## **Request for Class II Permissive** Change

Data: February 3<sup>th</sup>, 2015 FCC ID: YZZHT802

**New PCB Layout view**

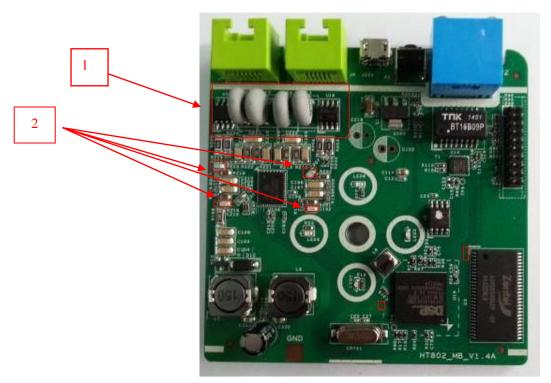
- 1. Upgrade hardware version from HT802 V1.3A to HT802 V1.4;
- 2. Add four PTCs for over current protect(see arrow 1);
- 3. Add four capacitors to remove Audio noise(see arrow 2);
- 4. Change the PCB layout(see the figure below);
